SERVICE BULLETIN

MODEL BD-700-1A10 (BD-700)

**MODIFICATION – HORIZONTAL STABILIZER –
 ADDITION OF DRAINAGE HOLES TO ELIMINATE WATER ACCUMULATION AND
 ADDITION OF RIVETS ON THE ACCESS PANELS NUTPLATE ASSEMBLIES**

SERVICE BULLETIN: 700-55-004 **ISSUE:** Basic **DATED:** Jul 26/2002

KGC991-1094
Kit – Empennage Drainage Provisions
(Sheet 2 of 3, Rev. C)

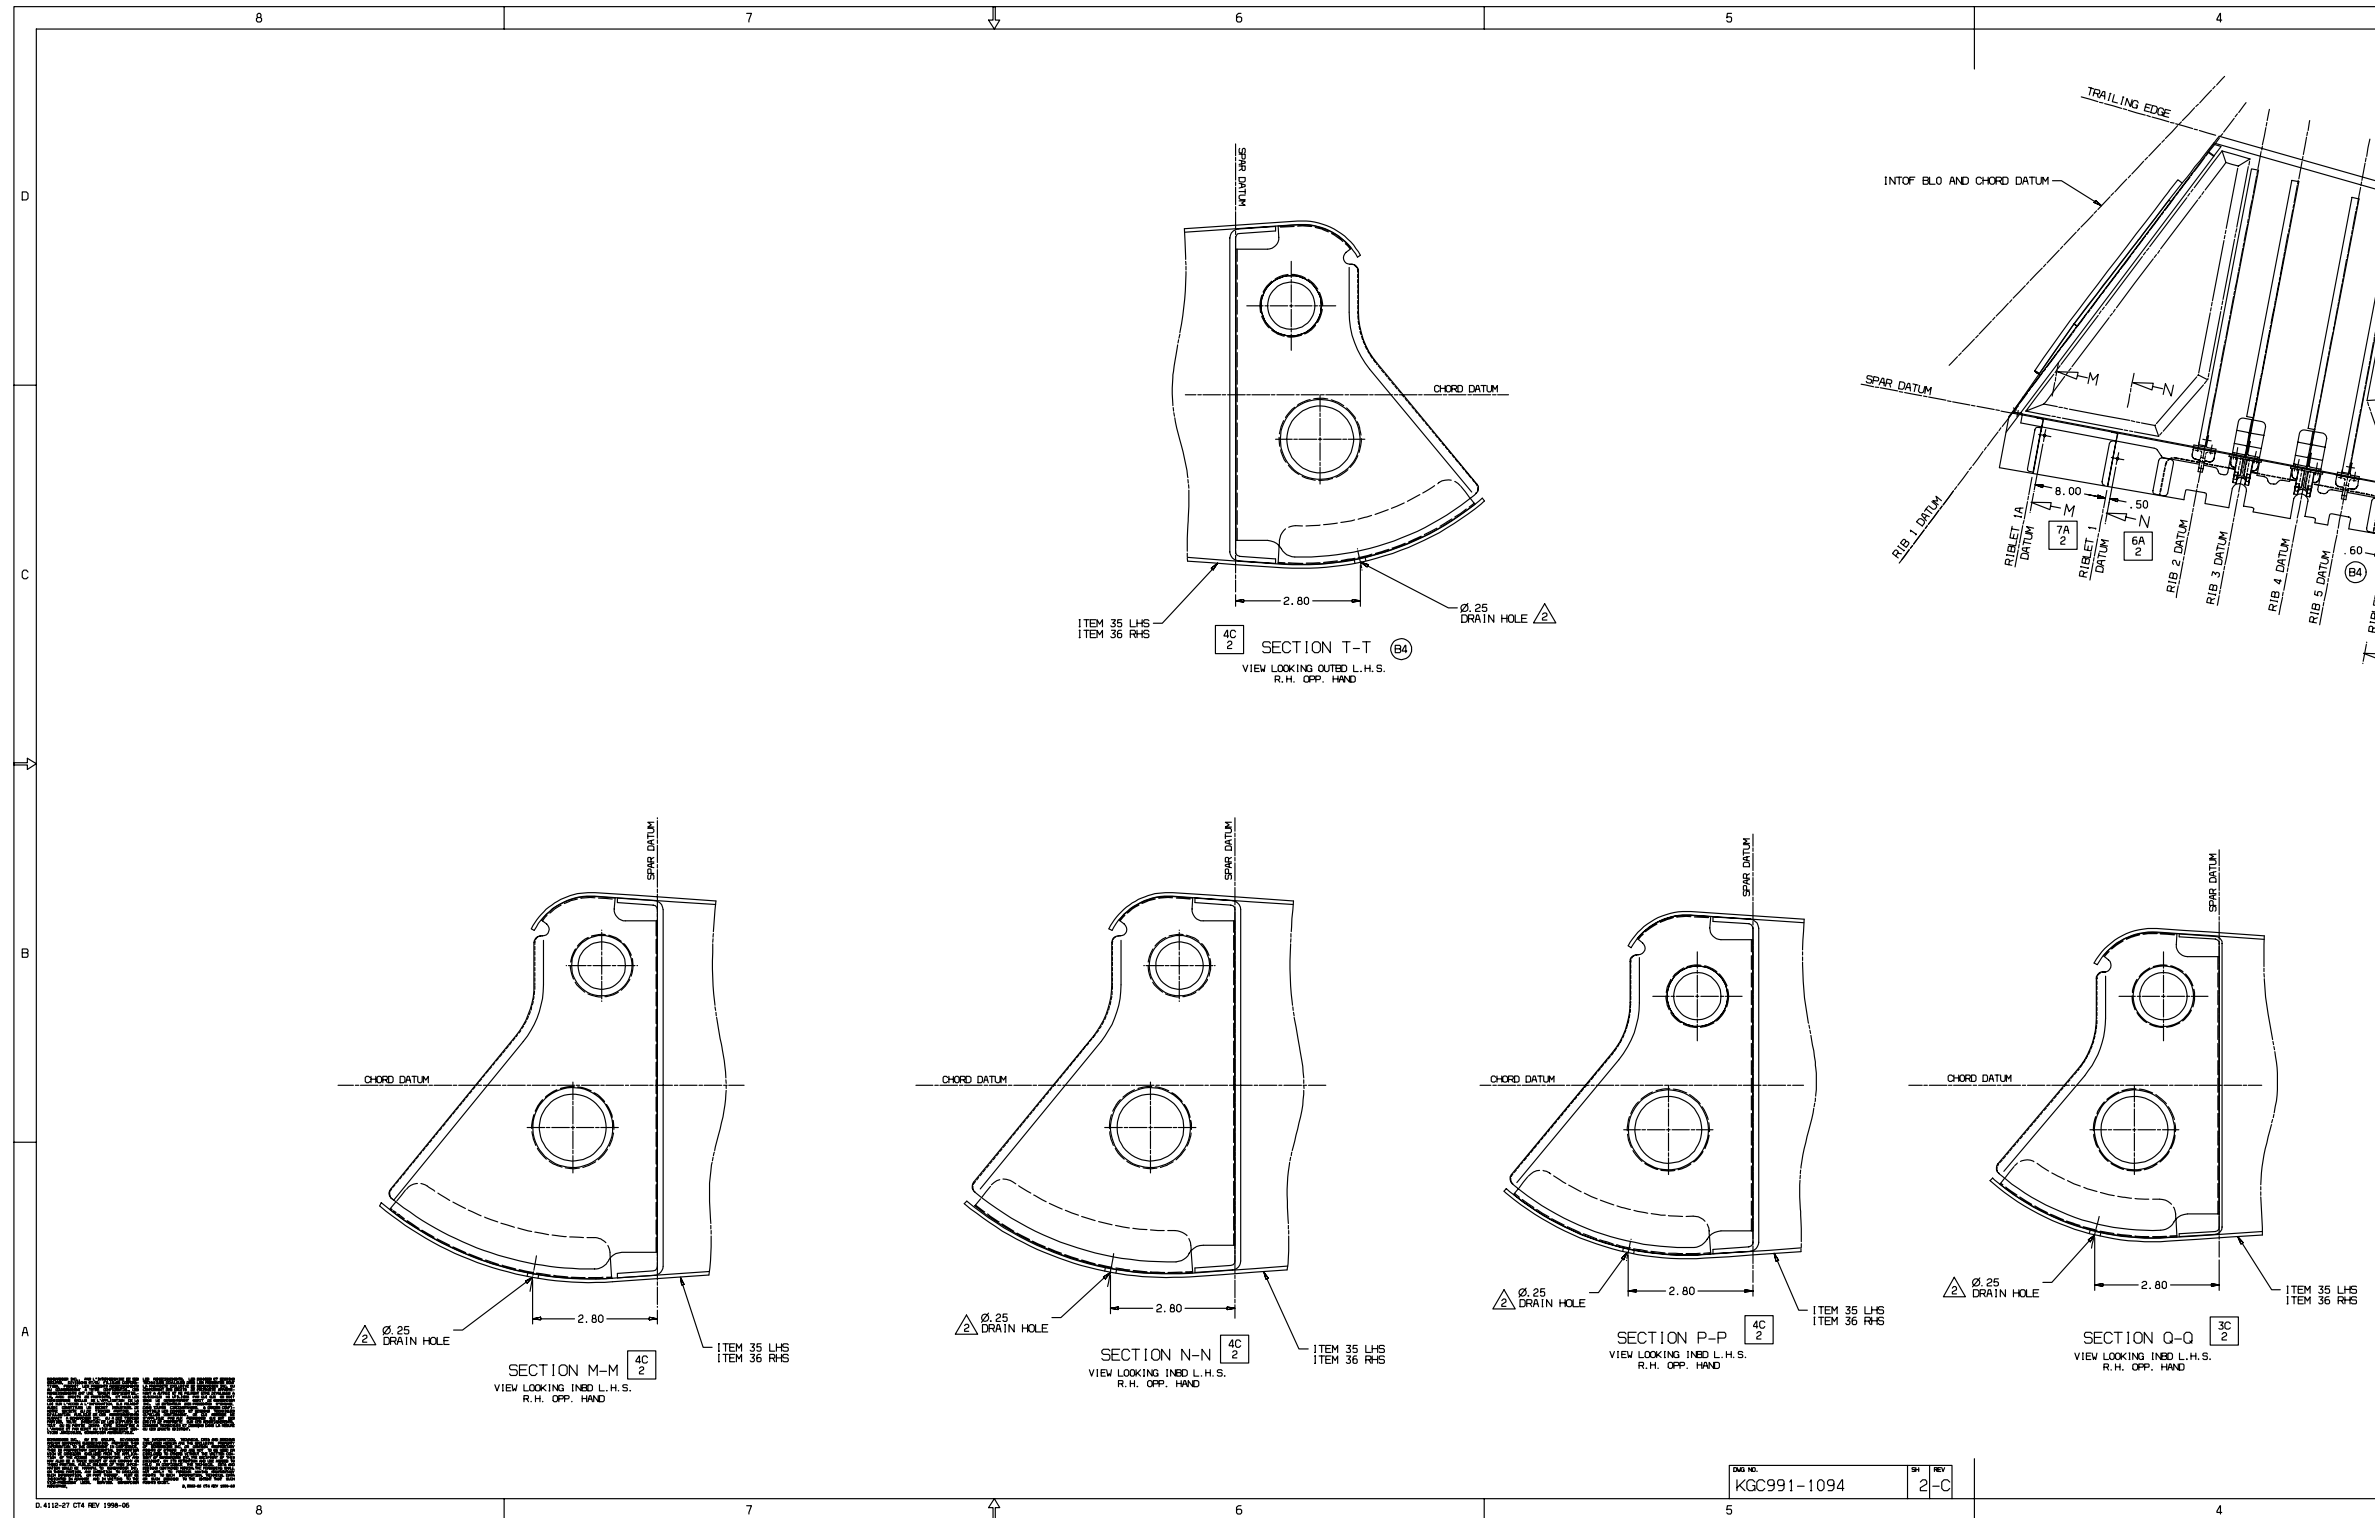
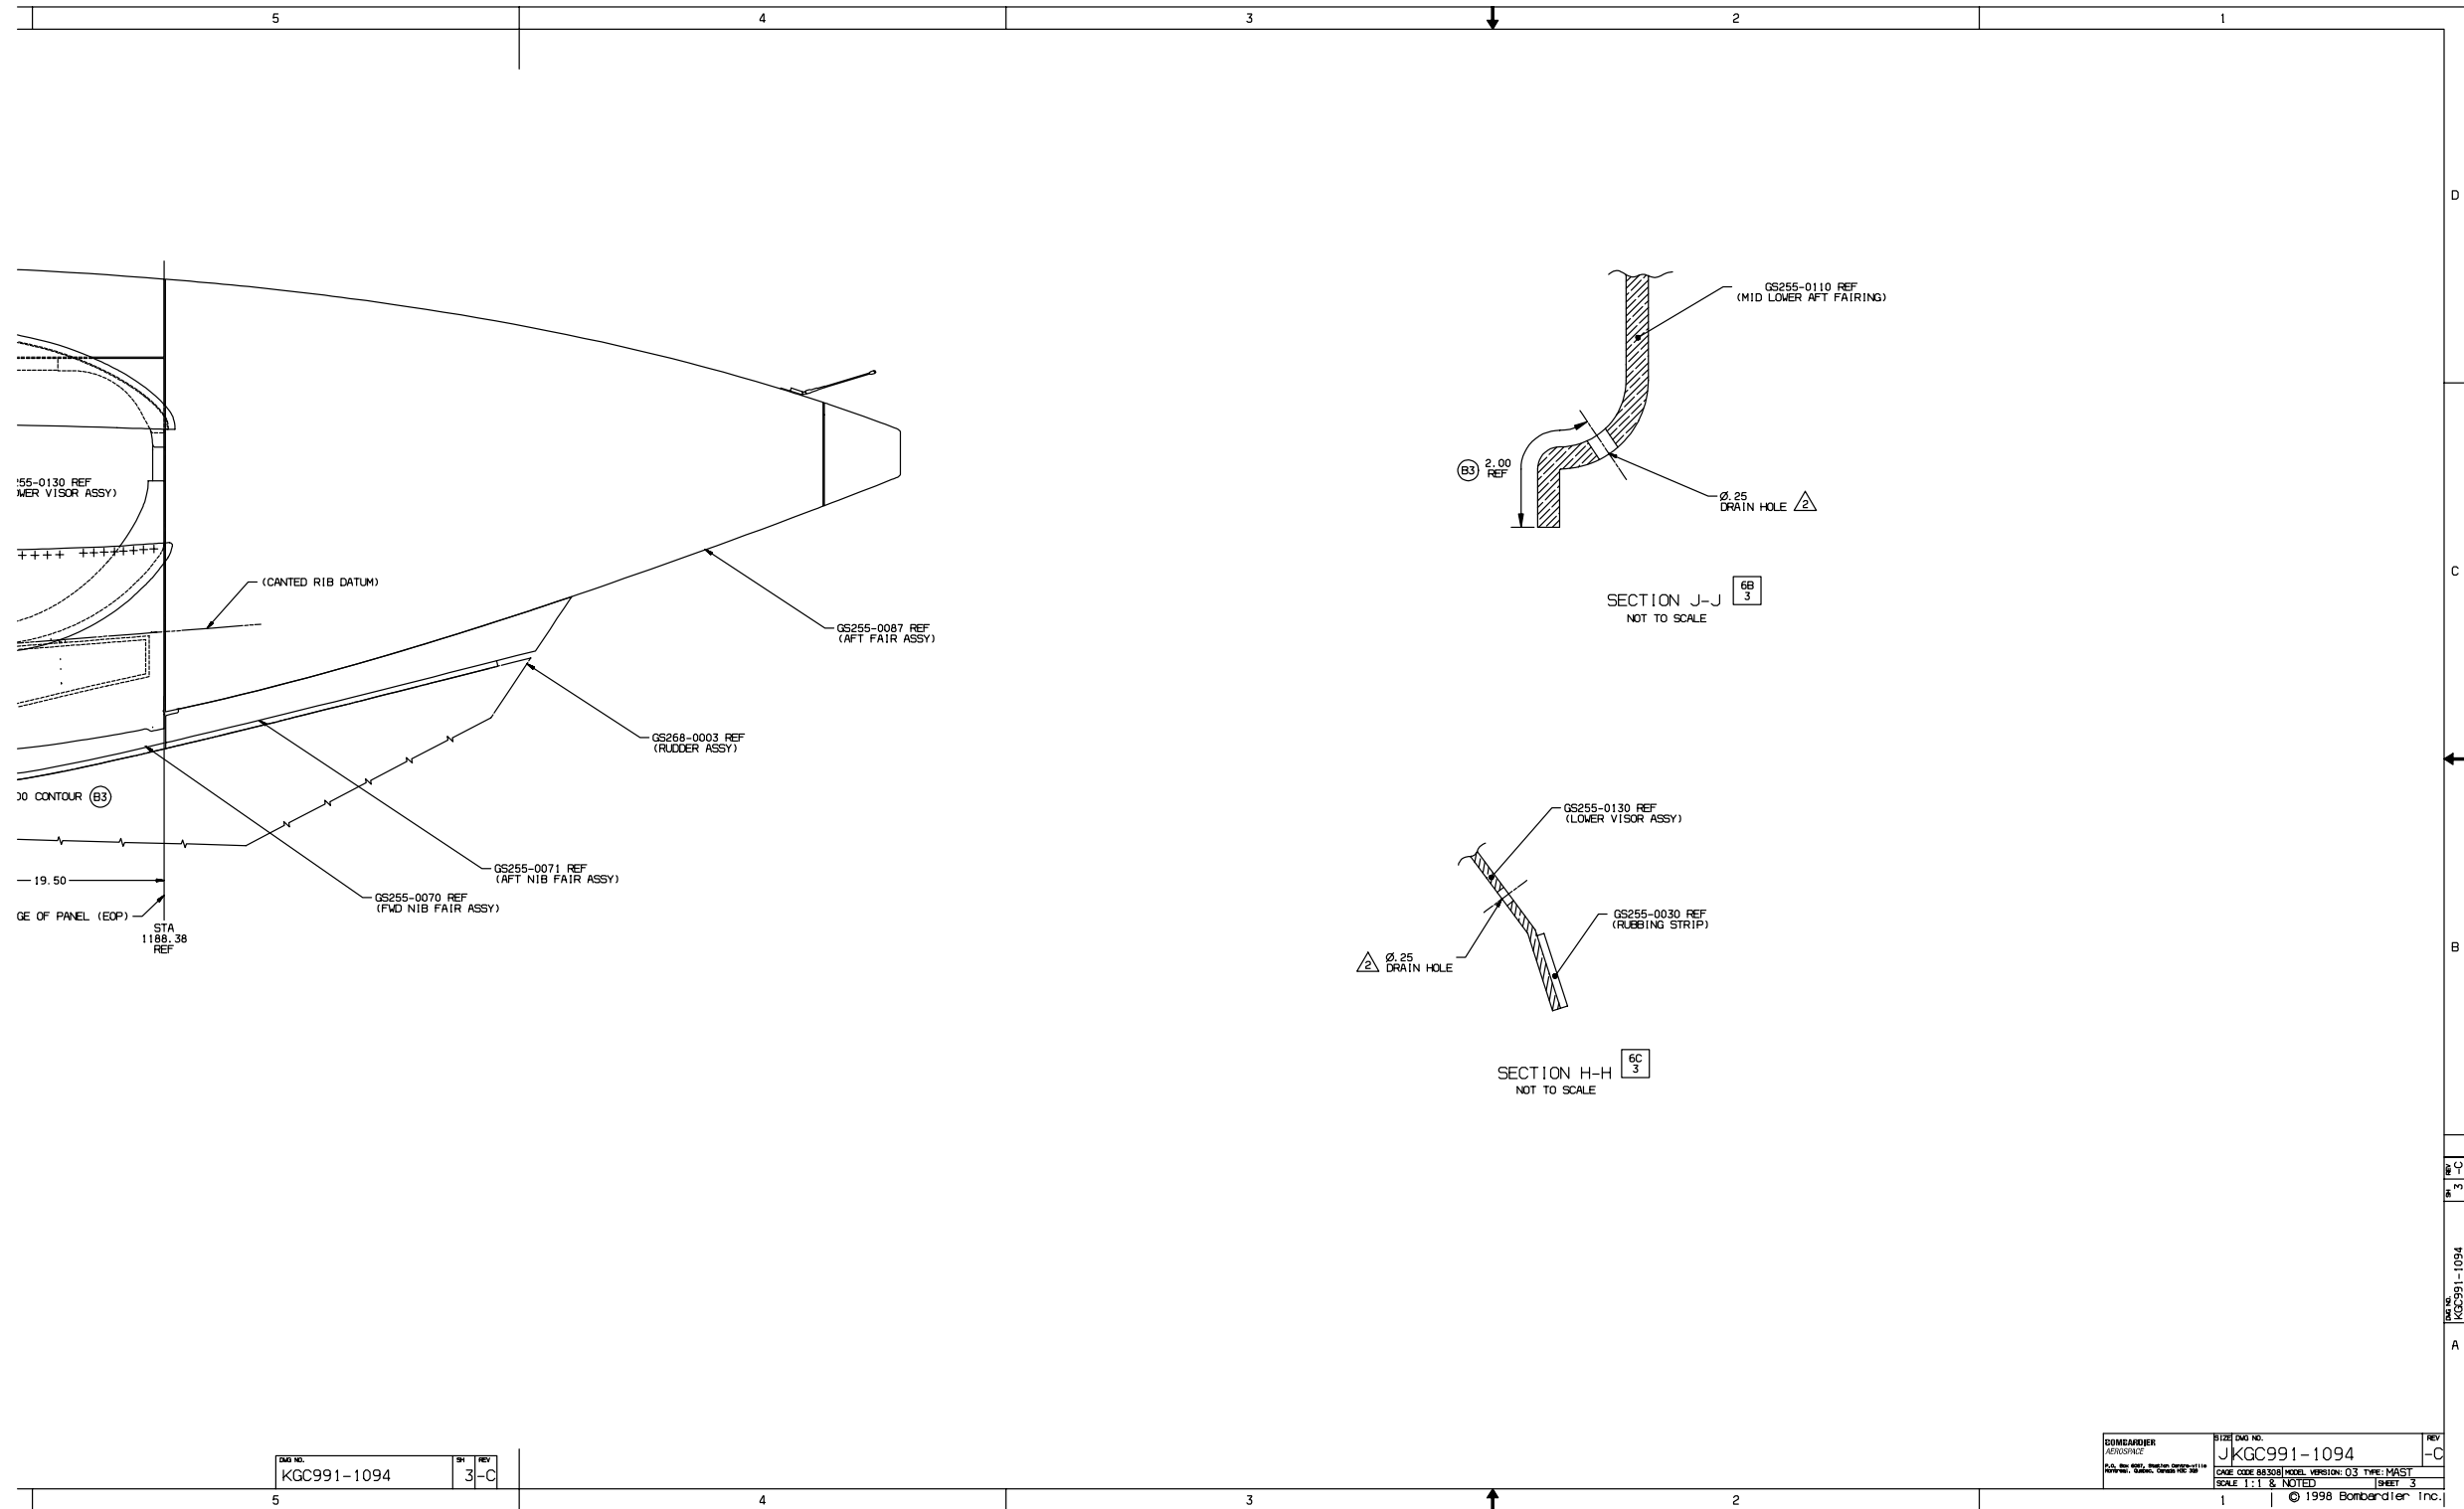
During a routine inspection, water accumulation was found within the lower visor fairings and the lower panels located above the horizontal stabilizer trailing-edge. PART A of this Service Bulletin gives instructions to add drain holes on the horizontal stabilizer and the elevator to avoid water accumulation. This will prevent early deterioration of structural components.

- Get access to the horizontal stabilizer,
- Remove the panels to be modified,
- Do the modification as per Kit Drawing KGC991-1094, and
- Re-identify and install the modified panels.

- (2) Remove the lower visor assembly 346JL and 346JR. Refer to TASK 55-10-05-000-810.
- (3) Remove the lower aft mid fairing 346FL and 346FR. Refer to TASK 55-10-05-000-806.
- (4) Do the modification to the fairings listed in the next table. Refer to the Kit Drawing KGC991-1094 and the procedure that follows:

FAIRING PART NO.	IDENT. CODE	TYPE OF ACCESS	FAIRING NEW PART NO.
GS253-0321-7	352AB	Access Panel	KGC991-1094-11
GS253-0321-8	362AB	Access Panel	KGC991-1094-12
GS253-0322-5	352BB	Access Panel	KGC991-1094-13
GS253-0322-6	362BB	Access Panel	KGC991-1094-14
GS254-0002-003	-	Lower Skin Torque Box	KGC991-1094-17
GS254-0002-004	-	Lower Skin Torque Box	KGC991-1094-18
GS255-0130-11	346JL	Access Panel	KGC991-1094-21
GS255-0130-12	346JR	Access Panel	KGC991-1094-22
GS253-0326-5	352EB	Access Panel	KGC991-1094-27
GS253-0326-6	362EB	Access Panel	KGC991-1094-28
GS255-0110-3	346FL	Lower Aft Mid Fairing	KGC991-1094-29
GS255-0110-4	346FR	Lower Aft Mid Fairing	KGC991-1094-30
GS274-0002-9	-	Skin Panel Assy Lower	KGC991-1094-31
GS274-0002-11	-	Skin Panel Assy Lower	KGC991-1094-32
